**DEVIATION REVIEW
 AND DECISION FORM**

Subdivision or Project Name: Falcon Marketplace

AutoTurn Exhibits

Figure 1

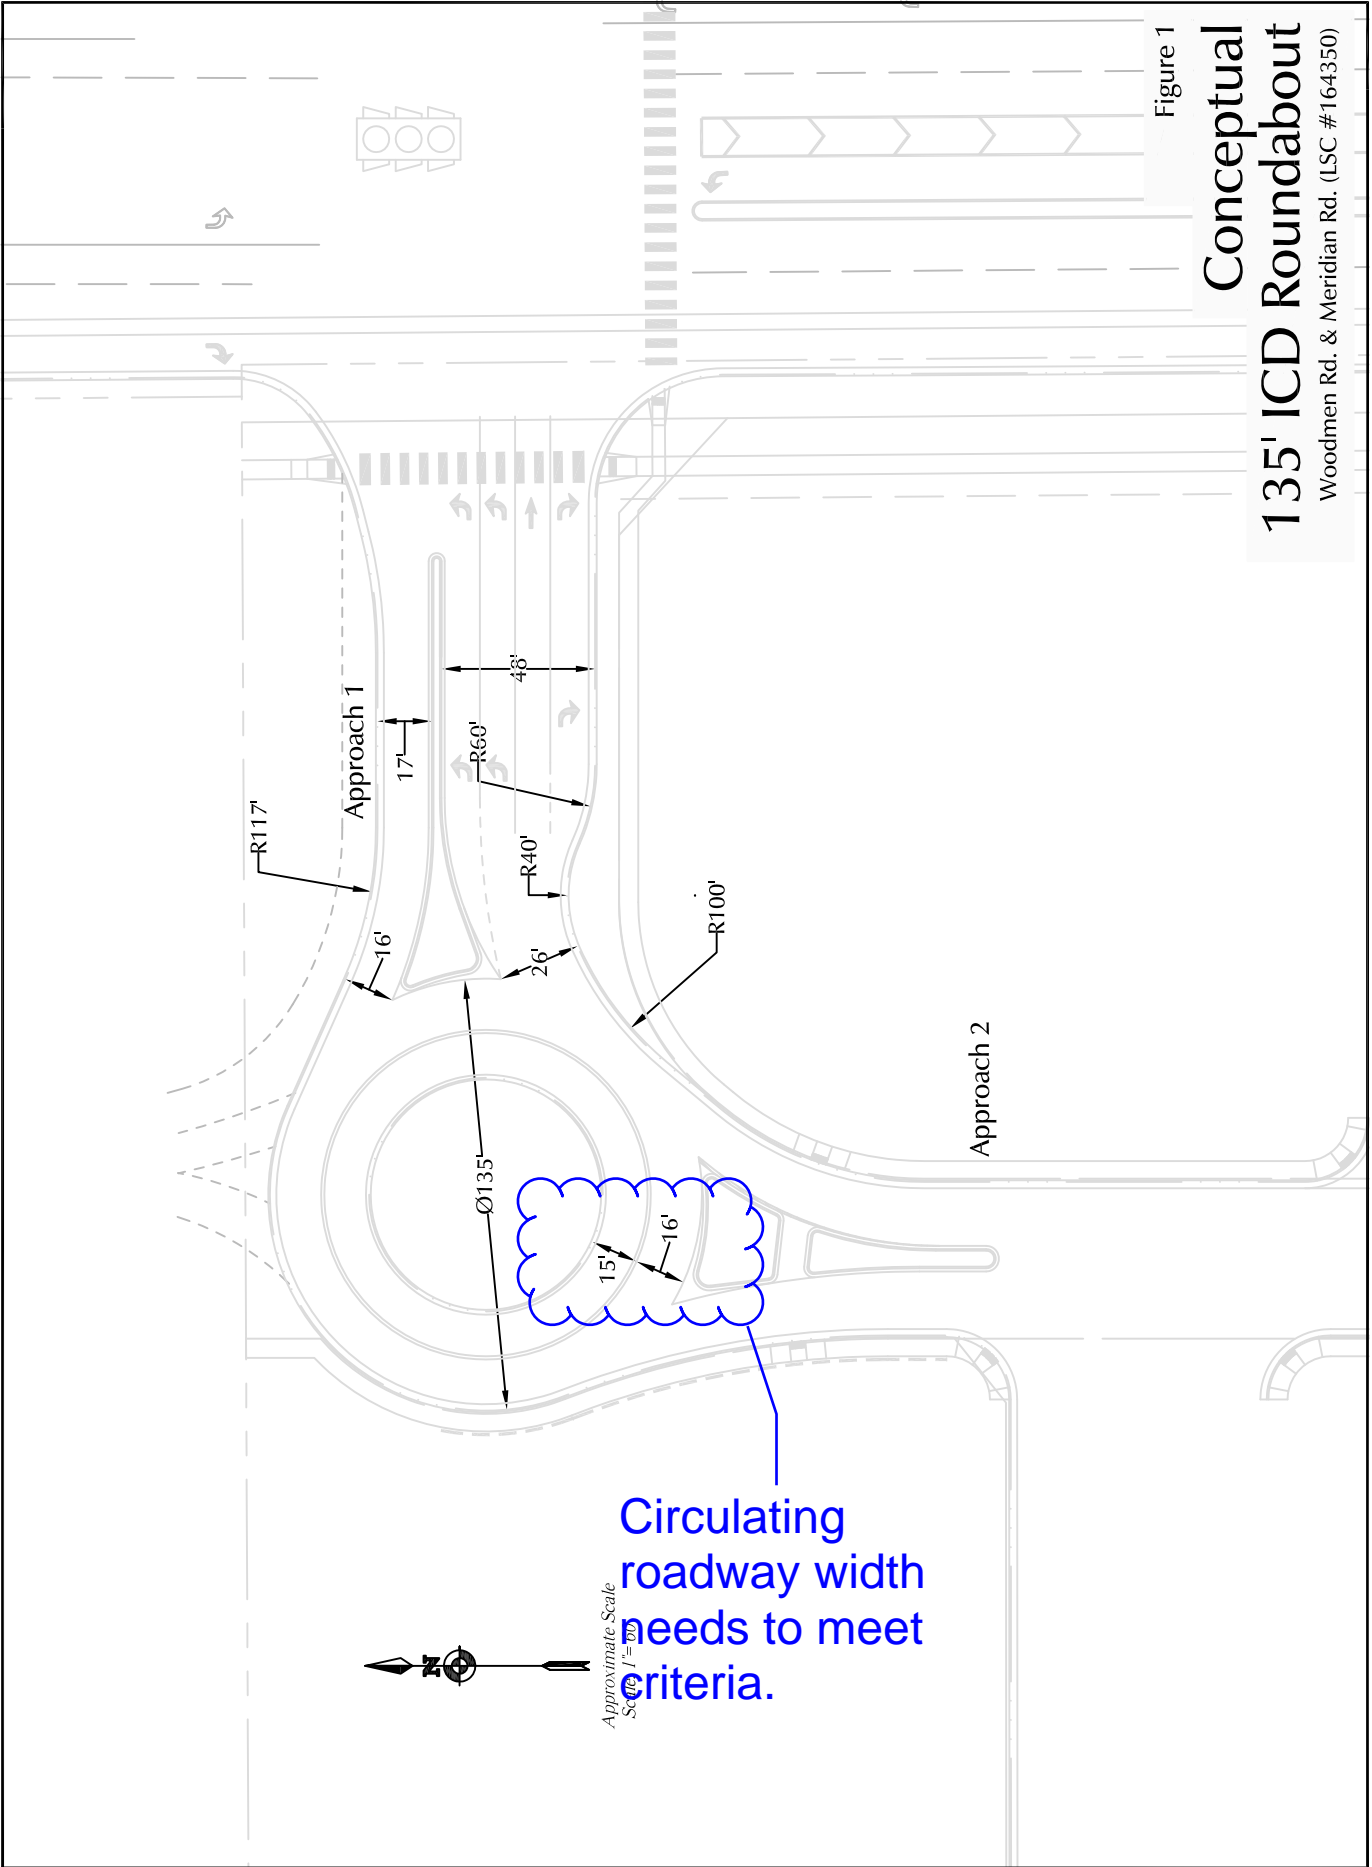
Circulating roadway width needs to meet criteria.

Figure 4

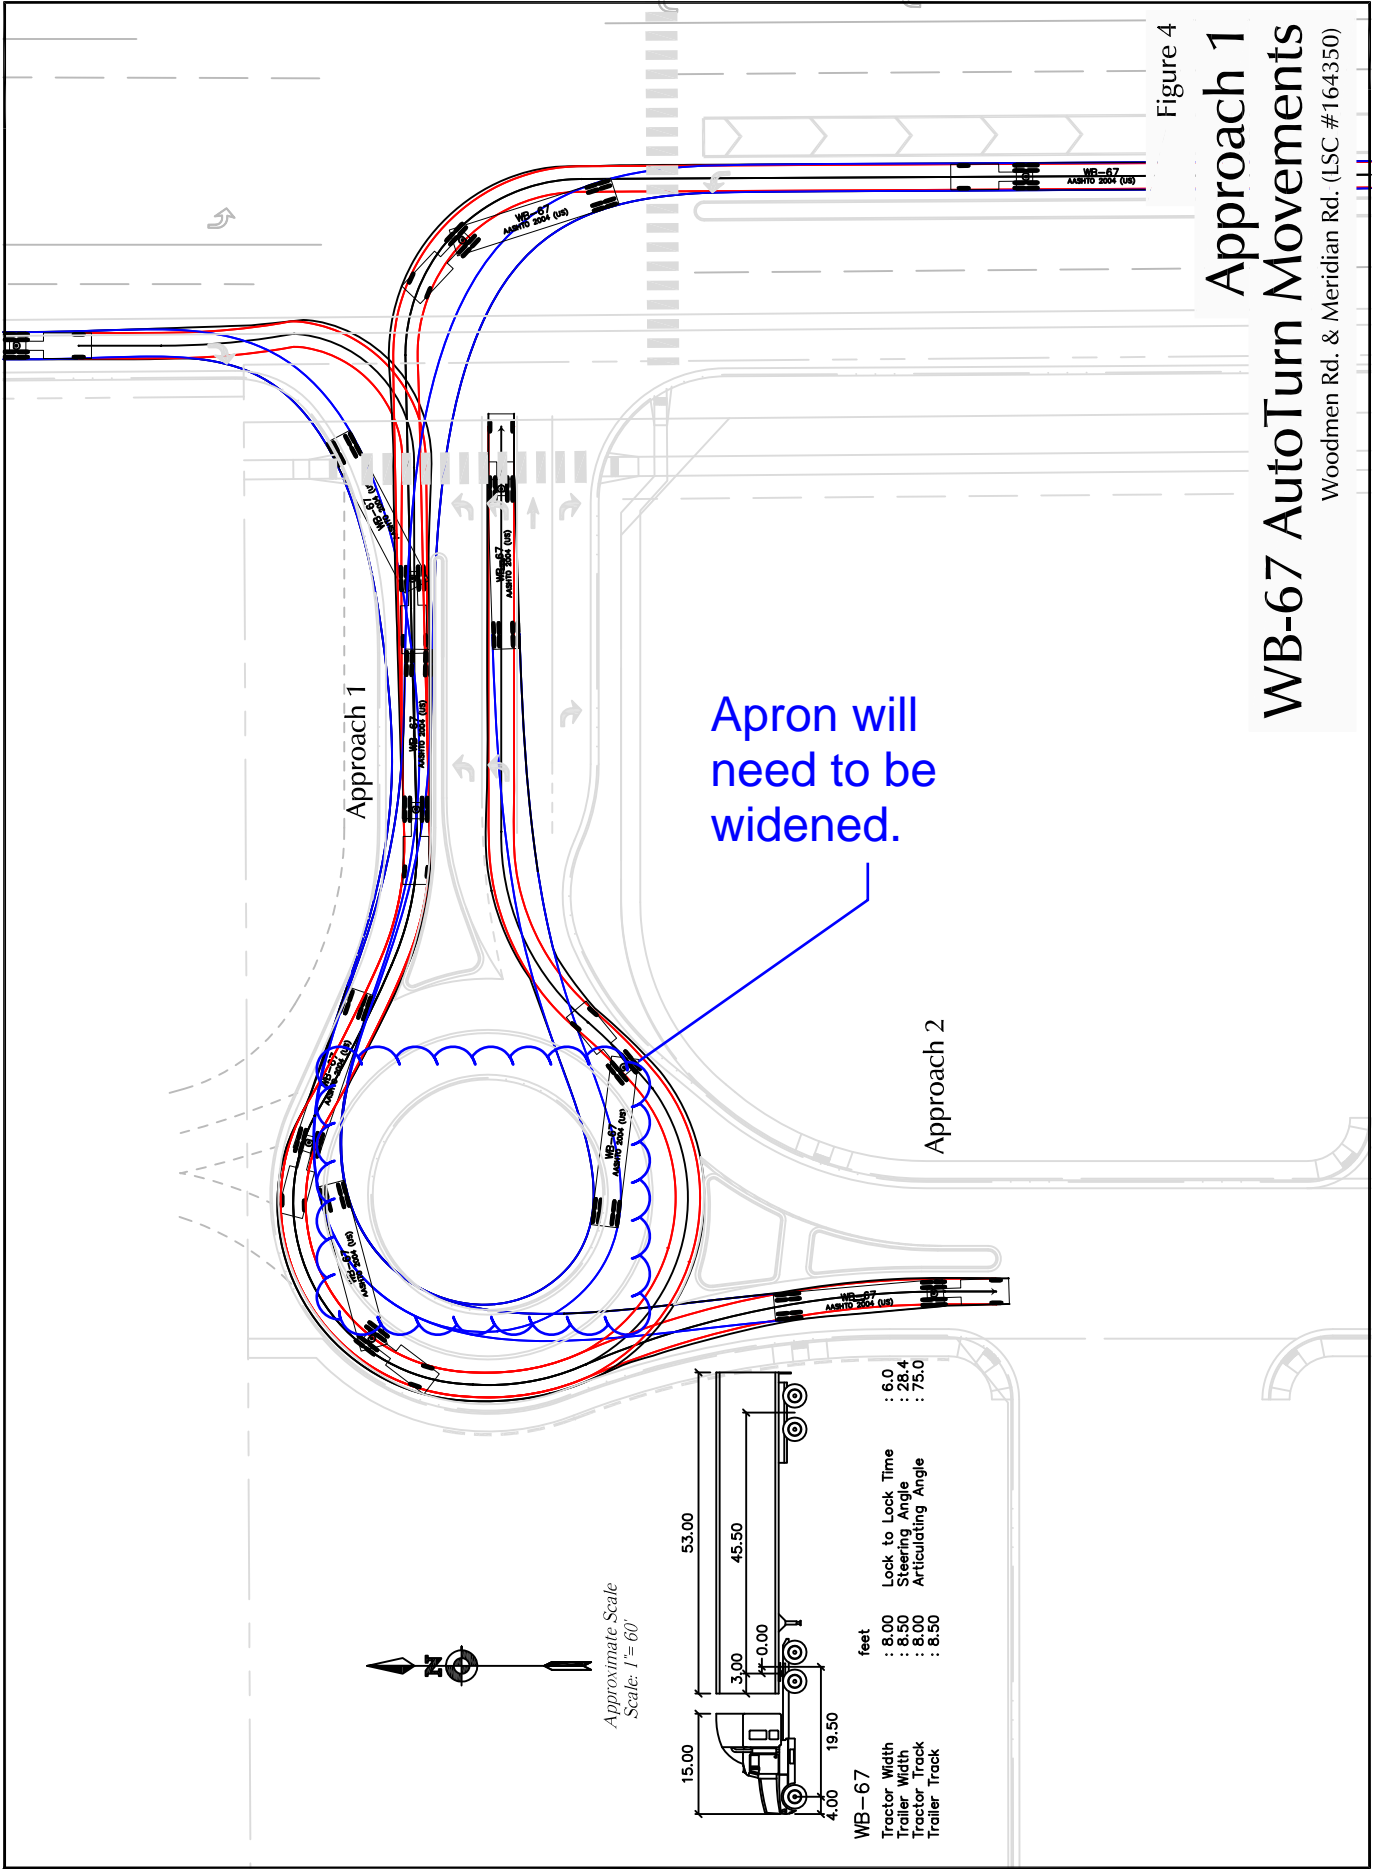
Apron will need to be widened.

Figure 1

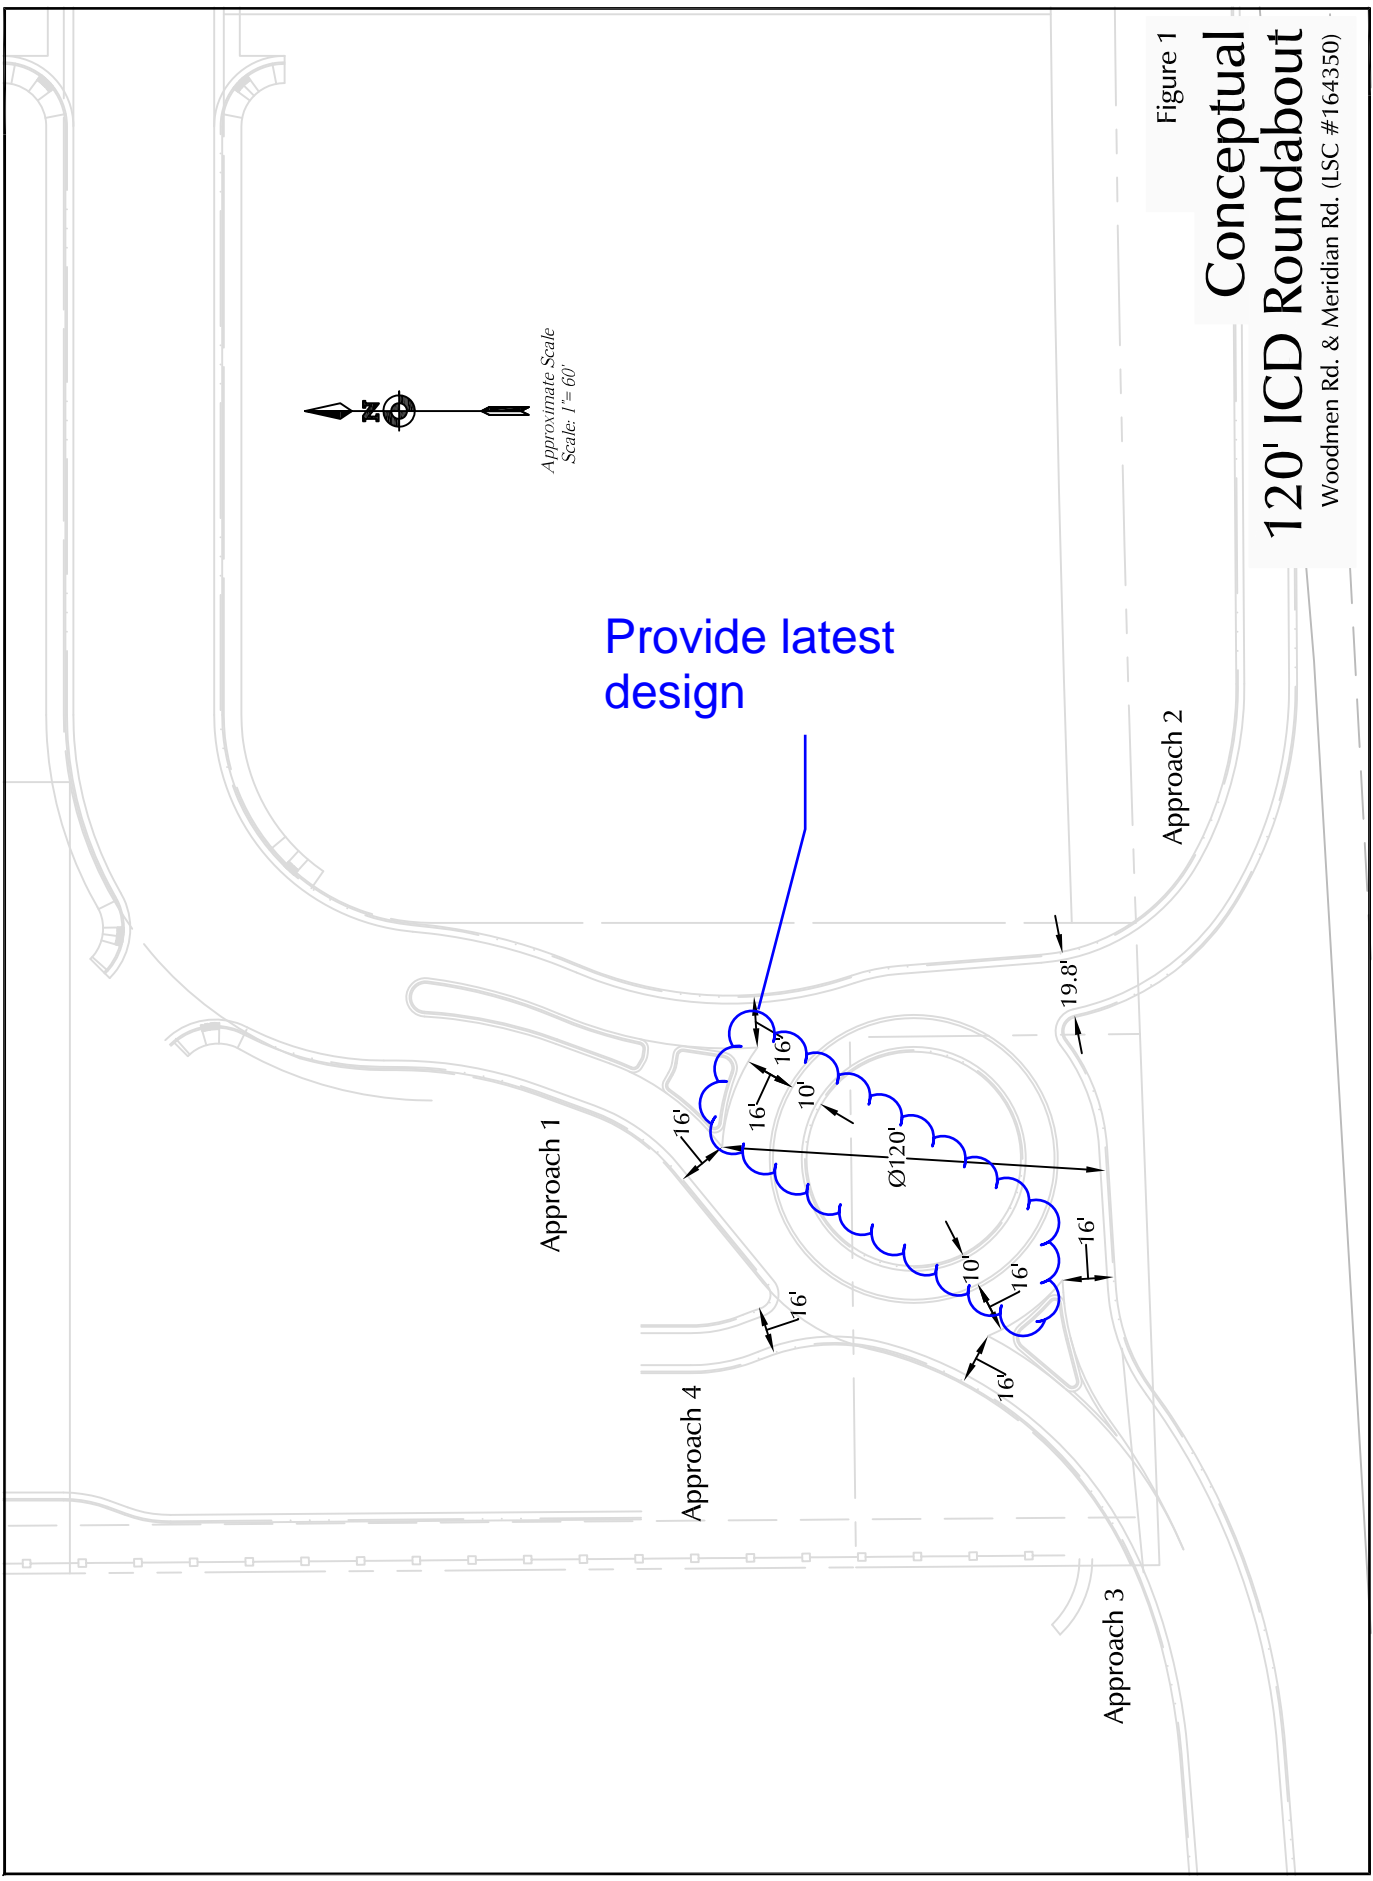
Provide latest design

Figure 6

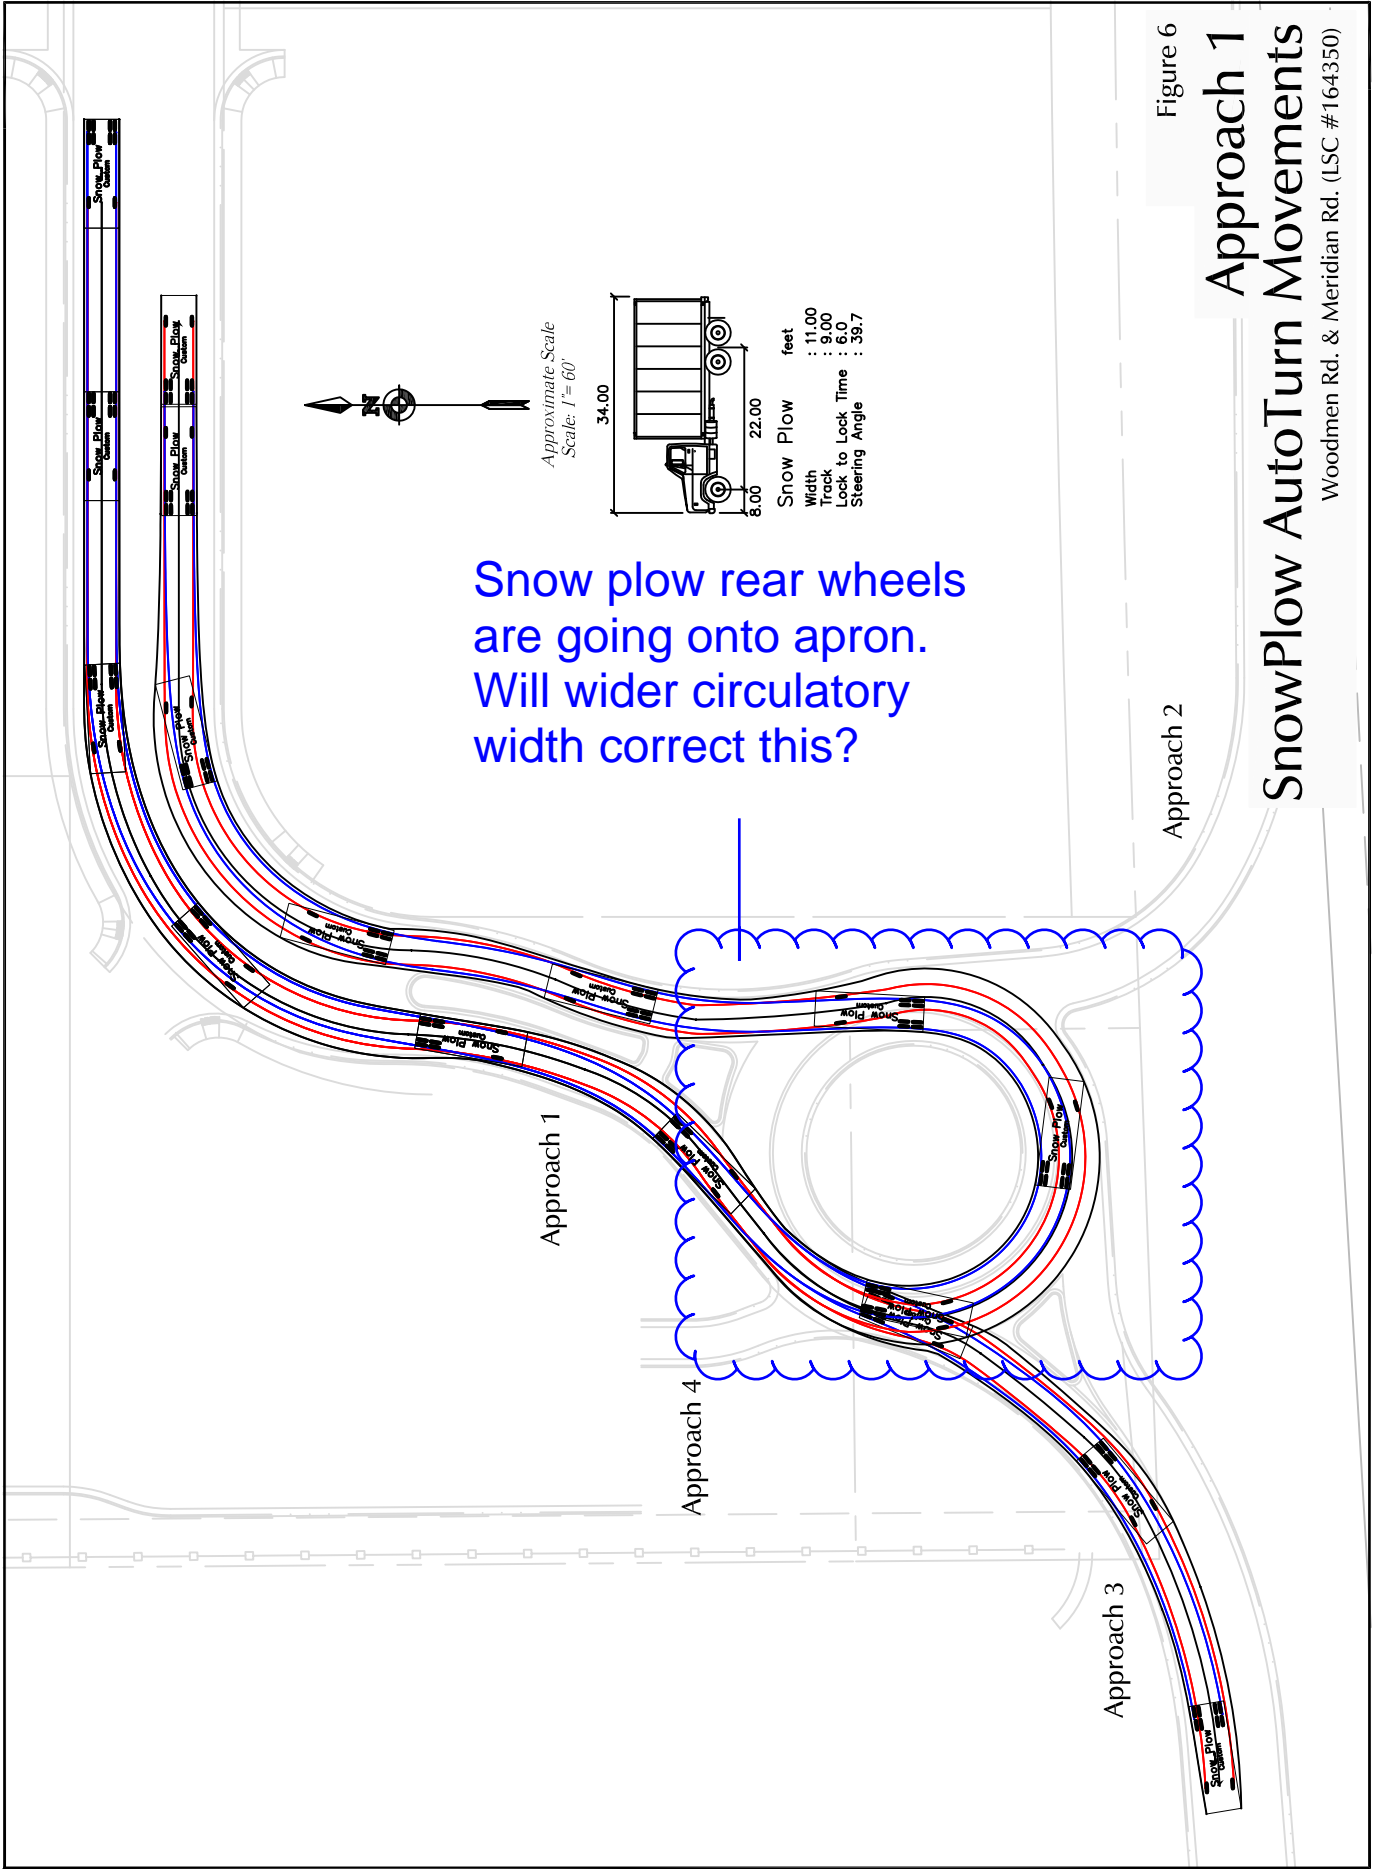
Snow plow rear wheels
are going onto apron.
Will wider circulatory
width correct this?
